October 9, 2020

Ms. Nancy Rumrill
U.S. Environmental Protection Agency, Region 9
Drinking Water Protection Services, WTR-4-2
75 Hawthorne Street
San Francisco, California 94105

Re: Transmittal of Supplemental Information in Support of Application for Underground Injection Control Permit, Florence Copper Project, Florence, Arizona

Figure 6. Groundwater Elevations

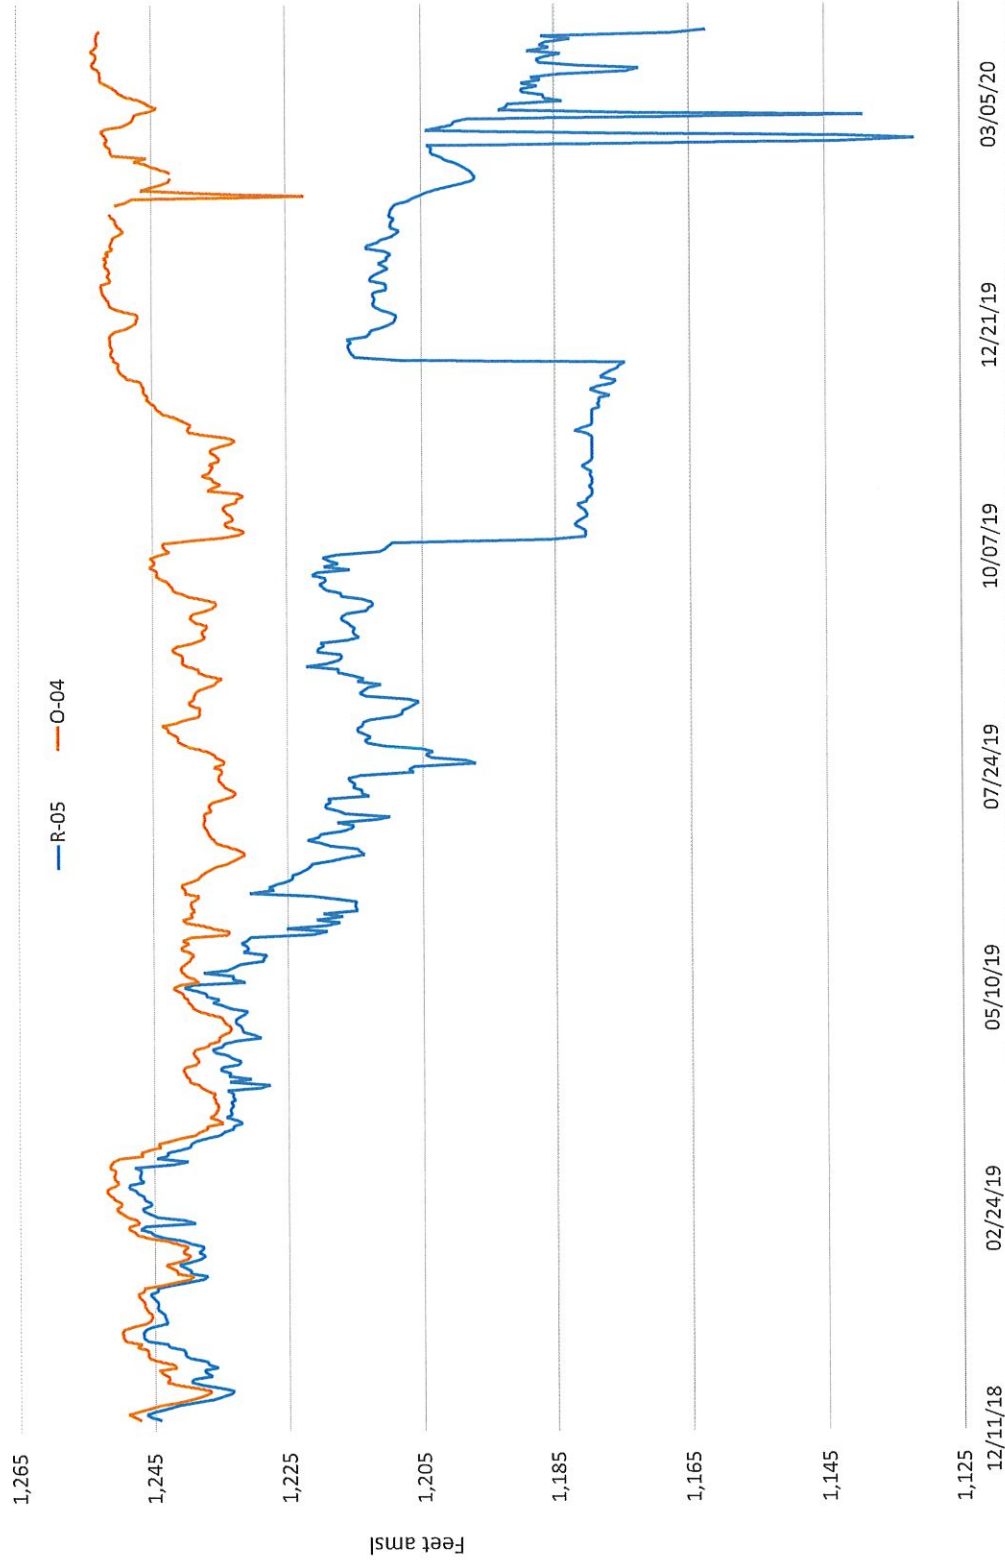
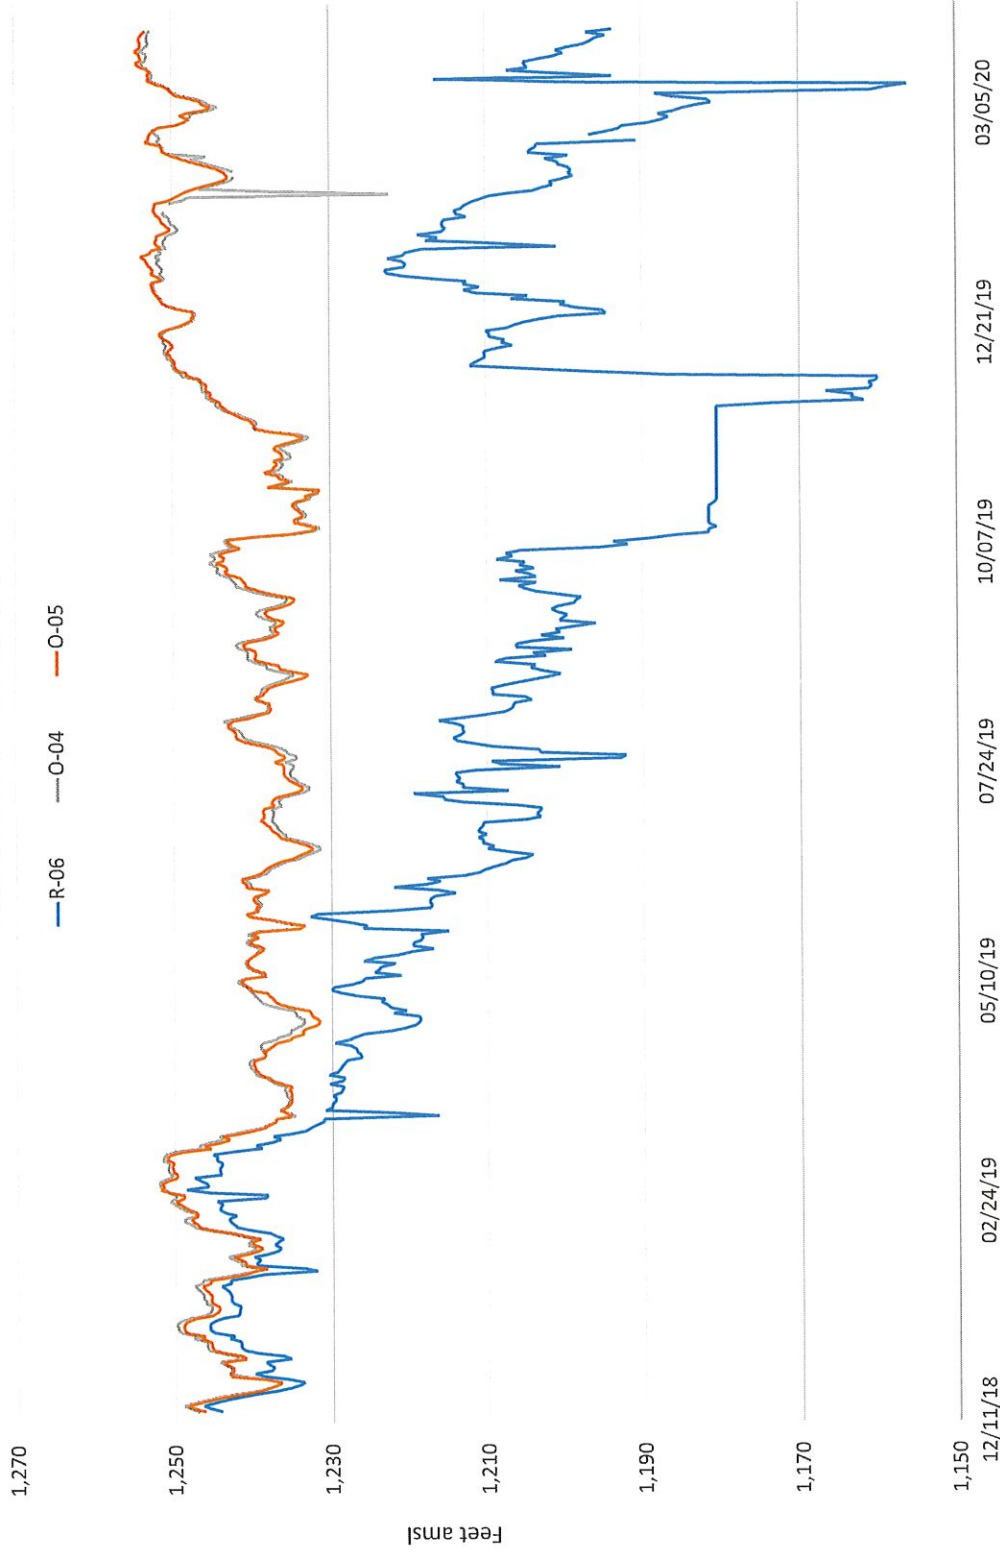
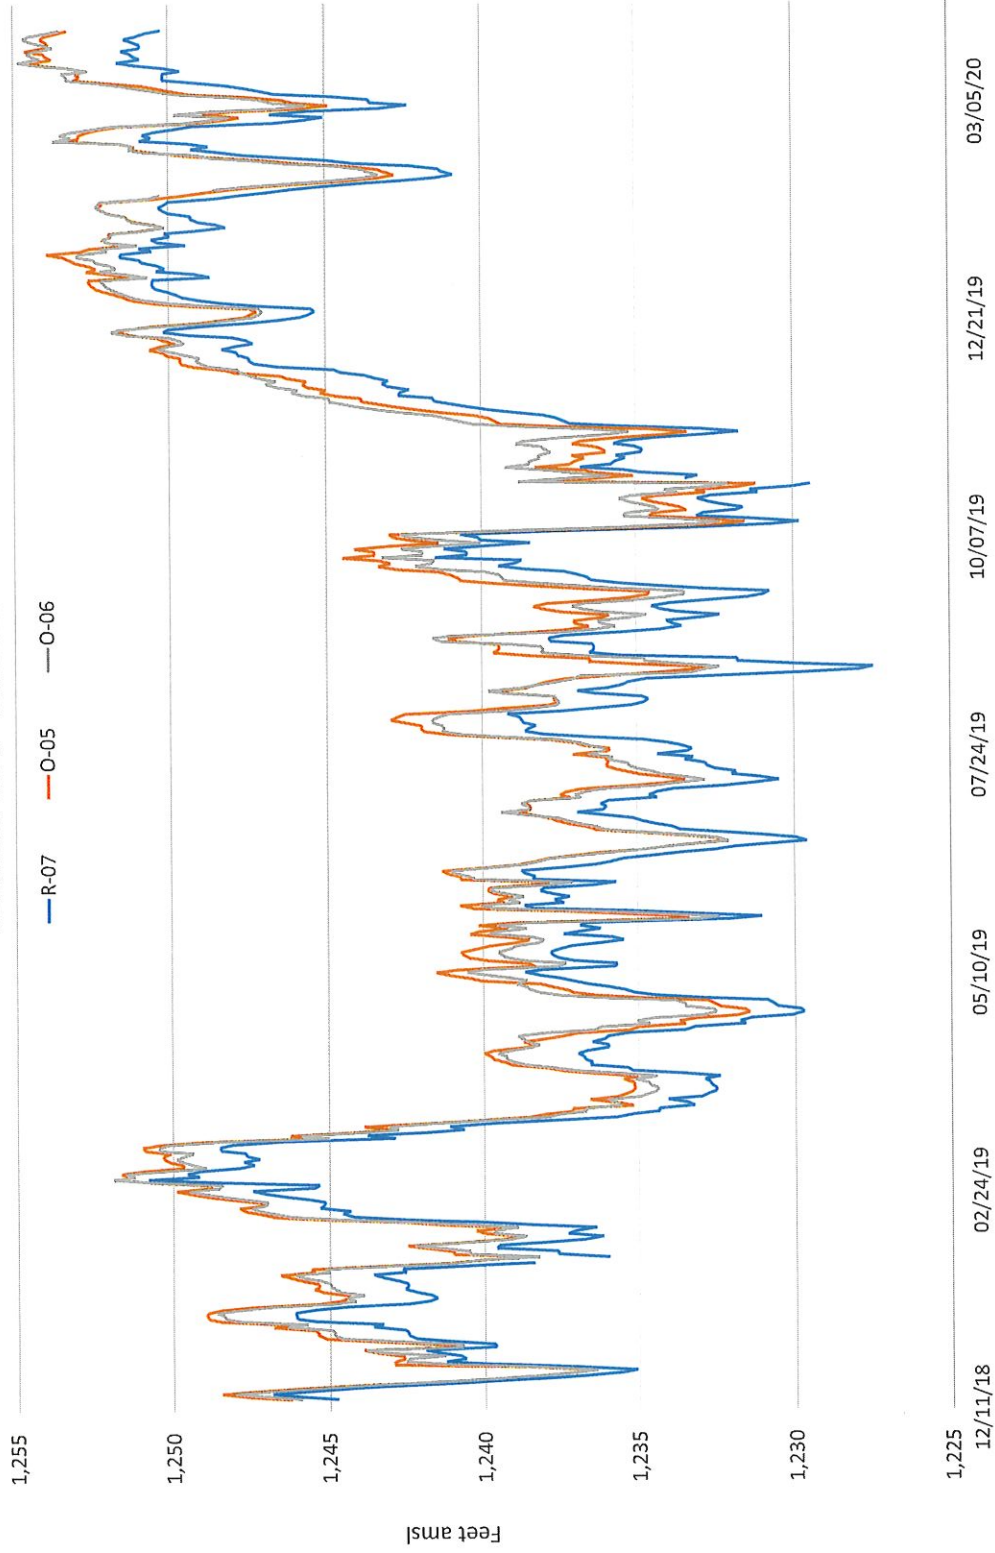
The USEPA requested that Florence Copper provide hydraulic control data from operation of the PTF wellfield.

Daily water levels measured at the PTF observation and recovery wells are plotted on Figures 1 through 8 for the period of operations spanning from December 2018 through the end of the second quarter of 2020. Data for quarter 3 of 2020 are currently being compiled and are not yet available for review. Figure 9 shows the relative locations of the wells for which water levels are plotted on Figures 1 through 8. The water level data plotted on Figures 1 through 8 indicate groundwater elevations at the perimeter of the PTF wellfield were consistently higher than groundwater elevation within the wellfield, confirming the over-pumping sustained hydraulic control effectively and maintained an inward gradient during PTF operations. These data also show that Florence Copper has maintained the daily average minimum 1-foot inward hydraulic gradient between paired observation and recovery wells since the commencement of PTF operations on December 15, 2018.

The groundwater elevation comparison required by the Temporary APP and Part II.E.1.b of the UIC permit uses recovery and observation wells at the corners of the PTF wellfield in relatively close proximity to one another on adjacent sides of the wellfield. Because the observation wells were constructed at the edge of the PTF wellfield using the same spacing as the injection and recovery wells, each observation well experiences drawdown from two recovery wells. This configuration effectively means that Florence Copper must demonstrate inward groundwater flow from two directions in a relatively small area (a 71-foot distance in two directions), and that the 1-foot differential demonstration is dependent on the hydraulic conductivity of the oxide zone between the recovery and observation wells.

Because the hydraulic conductivity of the oxide zone is relatively high, the cone of depression between the recovery and observation wells is relatively flat. Despite this condition, and the fact that pumping rates at the PTF wells were relatively low (approximately 51 gallons per minute [gpm] per well over approximately 640 feet of screen in each injection well), Florence Copper was able to successfully maintain the required 1-foot differential throughout PTF operations through real-time monitoring and active management of pumping rates.
